HISTORIC AND DESIGN REVIEW COMMISSION

October 20, 2021

HDRC CASE NO: 2021-511
ADDRESS: 134 E MULBERRY AVE
LEGAL DESCRIPTION: NCB 1702 BLK 6 LOT 9, W25 FT OF 10
ZONING: R-4
CITY COUNCIL DIST.: 1
DISTRICT: Monte Vista Historic District
APPLICANT: Robert Lee/LindLee, LLC
OWNER: Charlie & Linda Gonzalez/GONZALEZ LINDA LOPEZ & CHARLES
TYPE OF WORK: Exterior alterations
APPLICATION RECEIVED: September 24, 2021
60-DAY REVIEW: Not applicable due to City Council Emergency Orders
CASE MANAGER: Katie Totman
REQUEST:

The applicant is requesting a Certificate of Appropriateness for approval to remove one (1) existing rear window and One (1) door and install one set of French doors.

South/backyard/area
of work

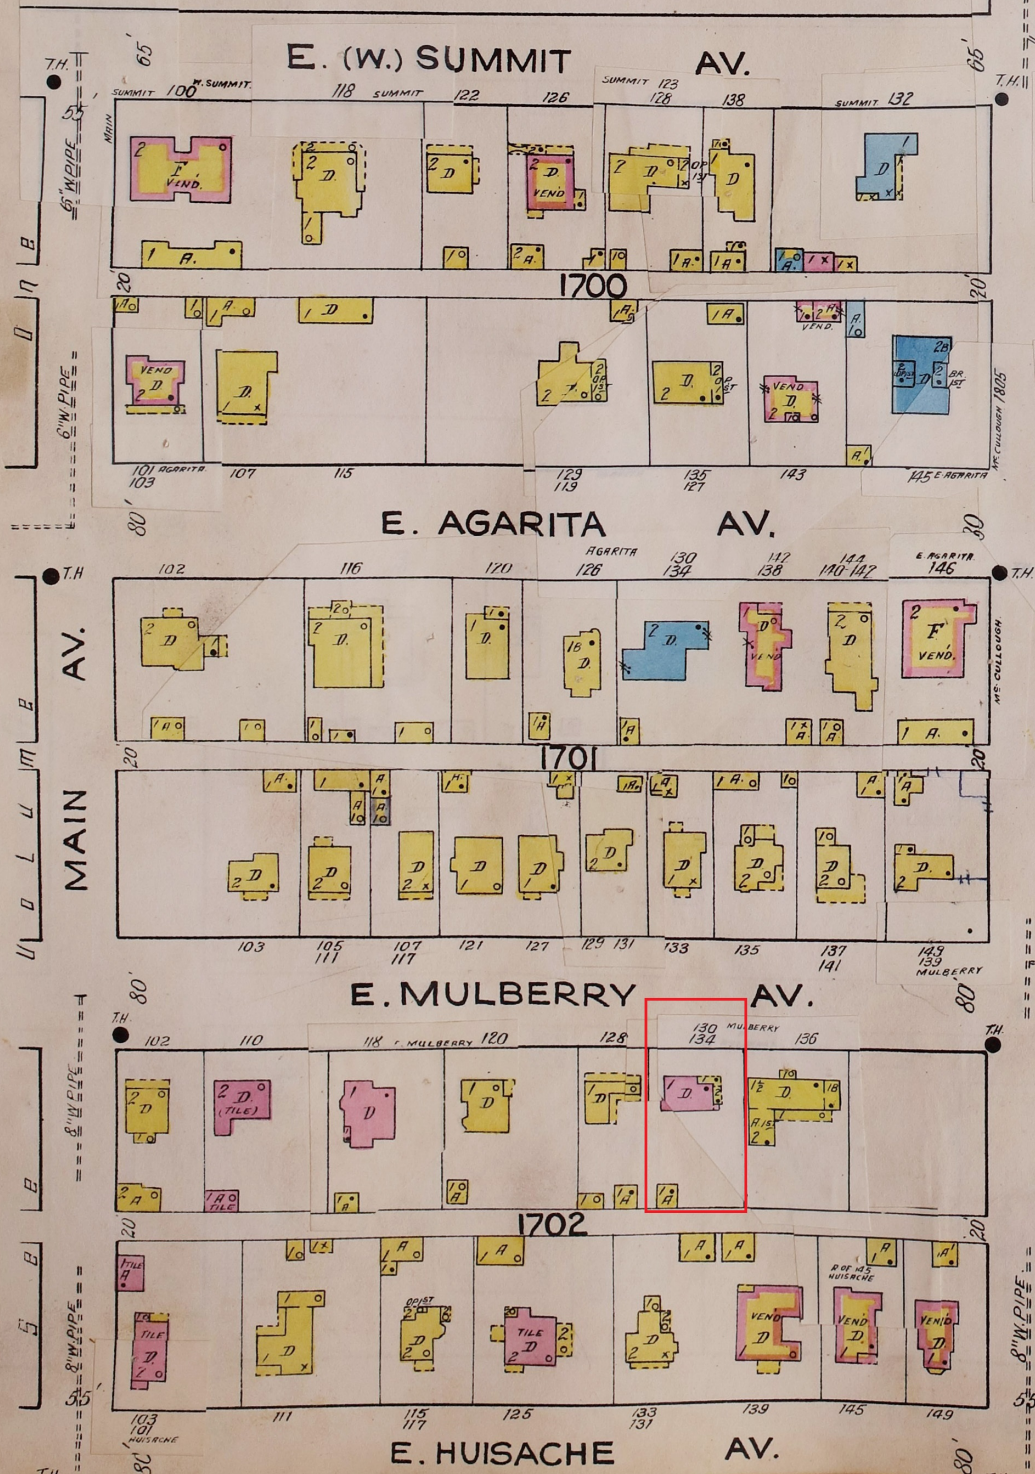
- b. EXTERIOR ALTERATIONS – The applicant is requesting to replace an existing one over one wood window and pedestrian door on the rear of elevation of the primary structure with new wooden French doors. The existing window has a smaller proportion relative to the majority of the historic window openings on the primary and secondary facades of the home. The modifications will not be visible from the public right-of-way. According to the Historic Design Guidelines, new elements should not significantly alter or destroy historic building character. Opening modifications should be compatible and should be appropriate for the building style. The proposed doors echo the rhythm and proportions on the existing structure and will utilize a portion of the existing window frame opening. Staff finds the request acceptable with the stipulations listed in the recommendation.

Staff recommends approval based on finding b. Staff recommends that the wood window that is removed be salvaged or stored on site for future use.
